WCAP-12391

WESTINGHOUSE BOILING WATER REACTOR  
EMERGENCY CORE COOLING SYSTEM EVALUATION MODEL:  
CODE DESCRIPTION AND QUALIFICATION

SUBJECT: ACCEPTANCE FOR REFERENCING OF LICENSING TOPICAL  
REPORTS WCAP-11284 AND WCAP-11427 REGARDING THE  
WESTINGHOUSE BOILING WATER REACTOR EMERGENCY  
CORE COOLING SYSTEM EVALUATION MODEL

Figure 12-6 Break Flow for TLTASA Test 6425/2

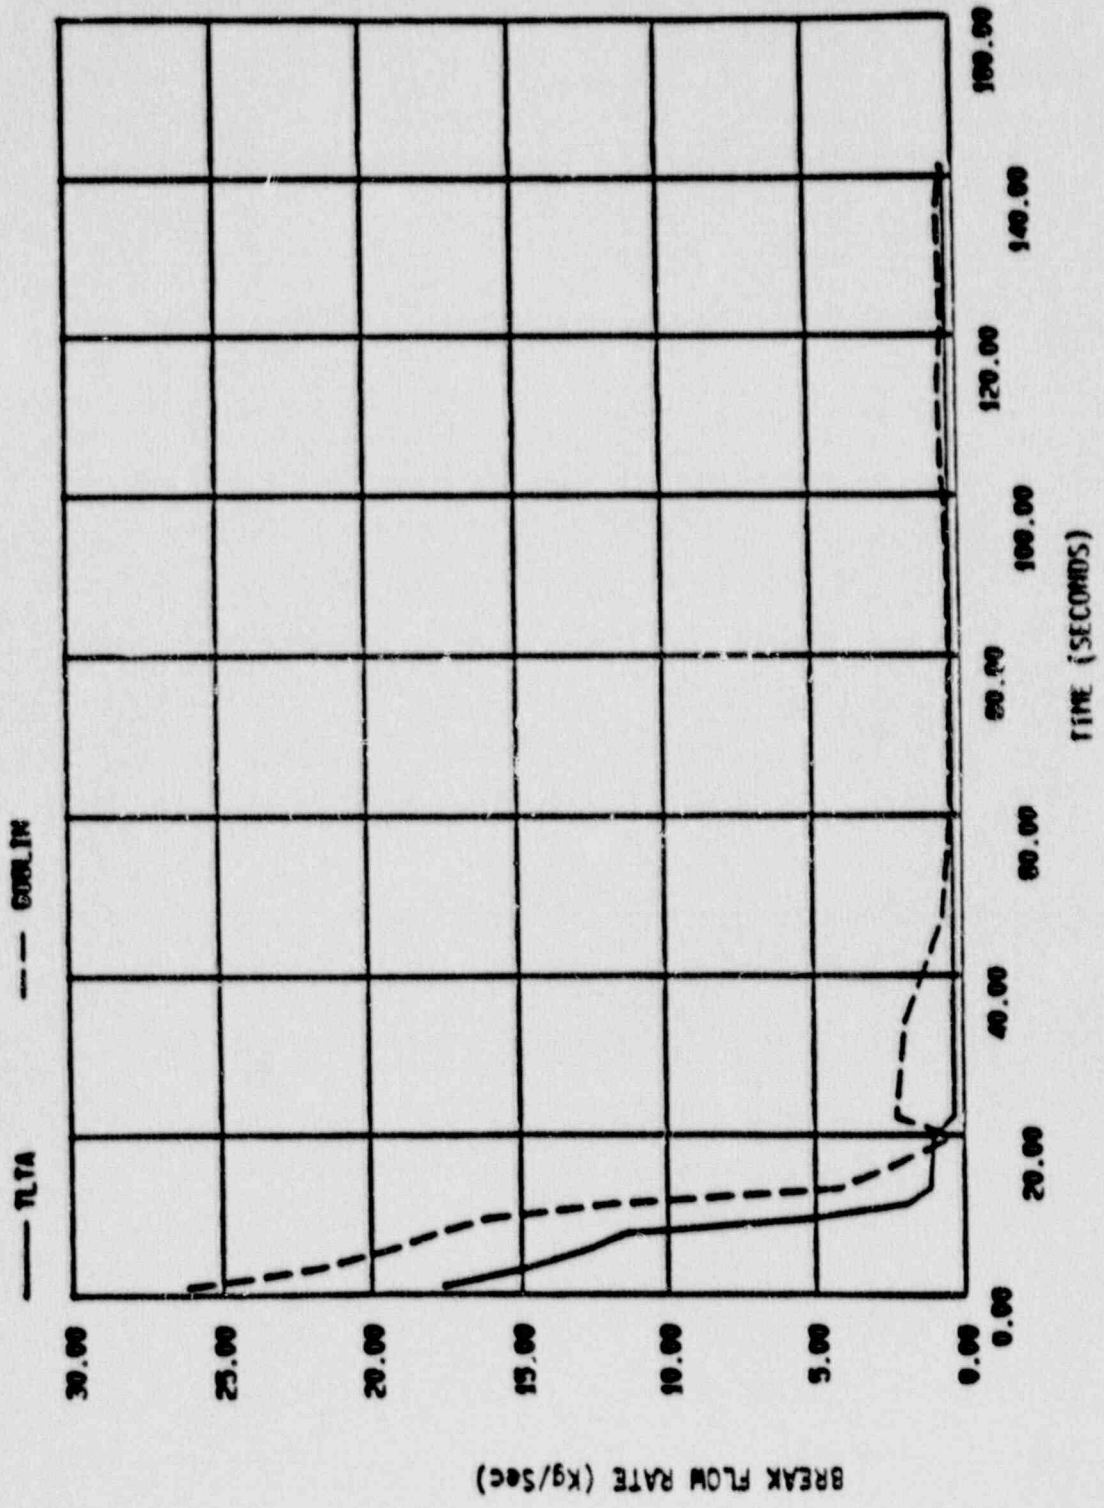
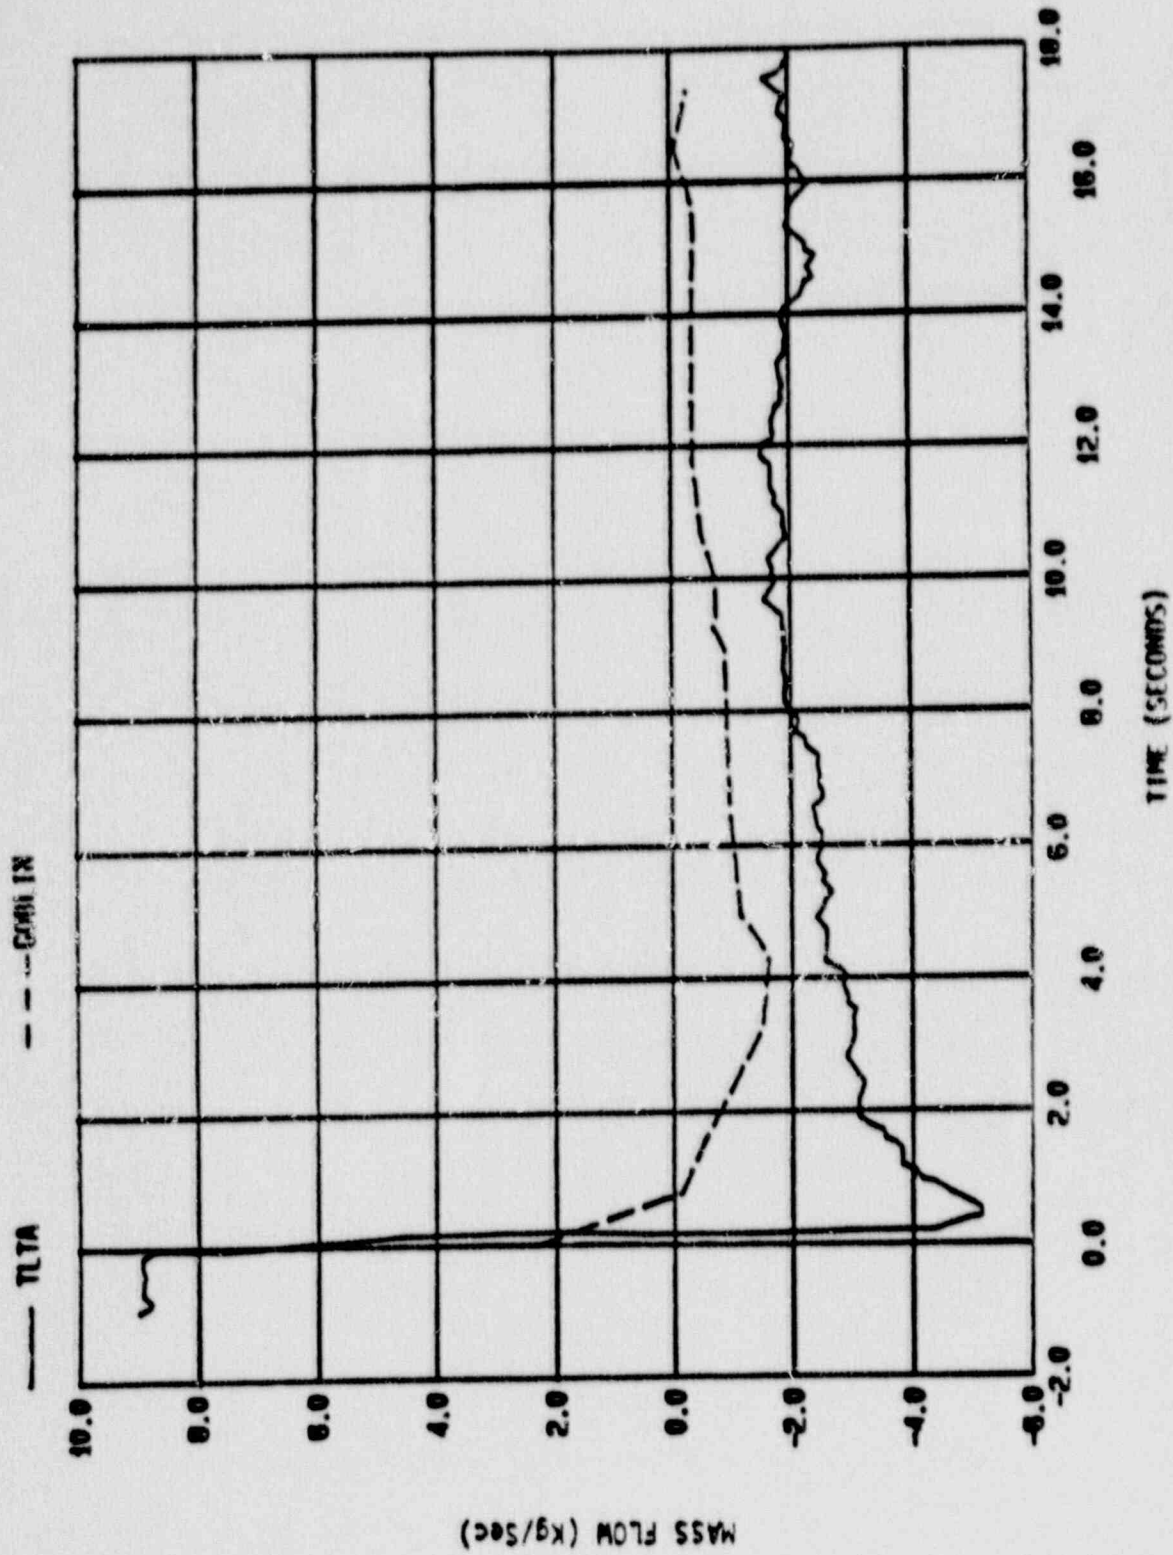
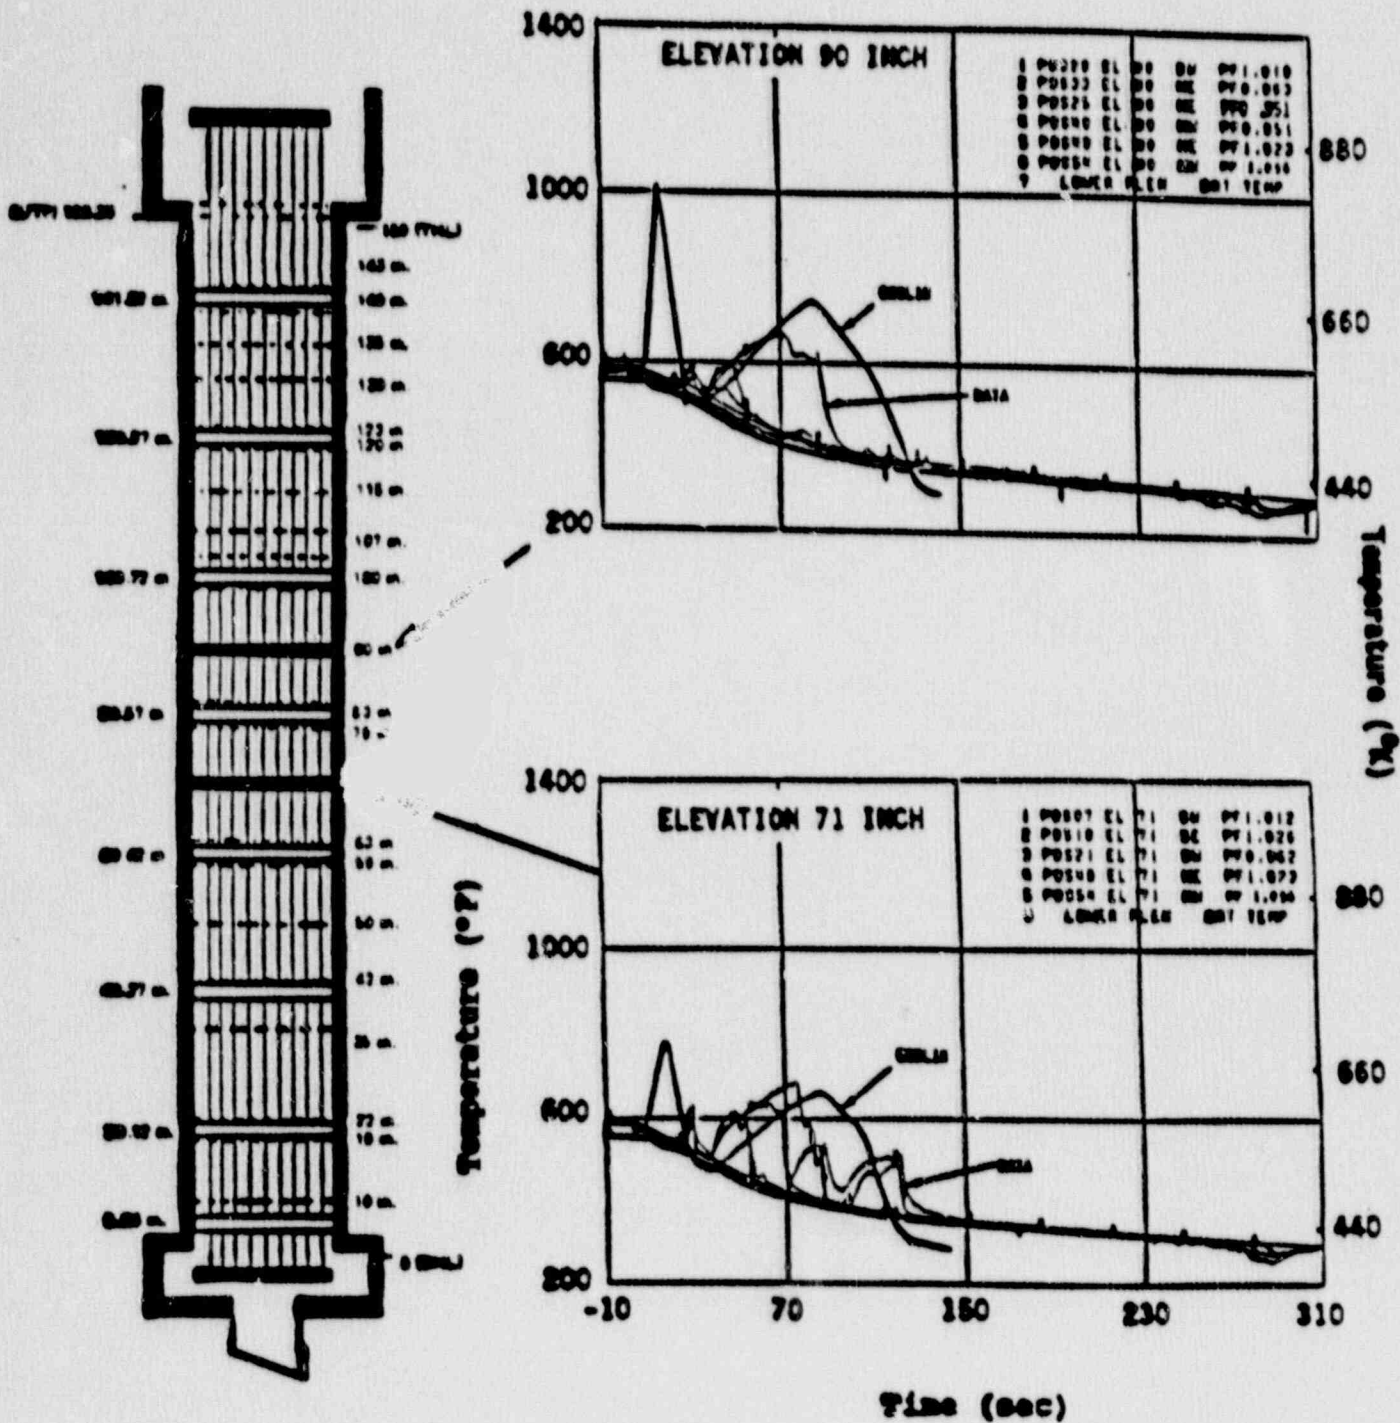
Pages 6-94, 6-98 and Sec. 6.2.3, Ref. 1. The rod temperature results are missing in the Westinghouse analysis of TLTA test 6425. In effect, these analyses have been presented in the form of separate-effects tests to demonstrate the correct response of the fuel rods. Based on Figs. 6-50 and 6-54, it appears that the code has no conservative margin in terms of PCT. In fact, the code predicts a cooldown from 40 s to 70 s in Fig. 6-50, and the data indicate a heatup. The observed differences need to be explained. Fig. 6-54 does not indicate which test rod the computational rod was simulating or what the differences are between the curves for the measured data. The rod locations for the measurement curves and which rod(s) were being simulated with the computational rod need to be identified.

The TLTA integral qualification simulation results of case 6425 run presented in Ref. 1 are repeated here. Table 12-1 shows the initial conditions for the test and simulation. Figures 12-1 through 12-7 are replotted comparisons of the transient hydraulic response. These figures supersede Figures 6-33 through 6-39 of Ref. 1. Figure 12-8 shows the corresponding rod temperature response.
